IMPORTANT — To assure product **SAFETY** and **RELIABILITY**, repairs, maintenance or adjustments should be performed by **MAKITA** Service Centers or other qualified service organizations. Always use **MAKITA** replacement parts.

SERVICE CHANGE

- Changes on Motor Bracket.

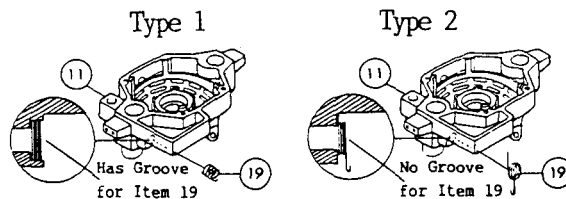
Fig.	Description	Type 1	Type 2
11	Motor Bracket	Part #157328-8 (Discontinued)	Part #155763-4
19	Spring	Part #231250-8 Compression Spring 10	Part #231574-2 Torsion Spring 15

The above parts are completely interchangeable as a set:
When replacing spring only, replace it with type 2 springs.
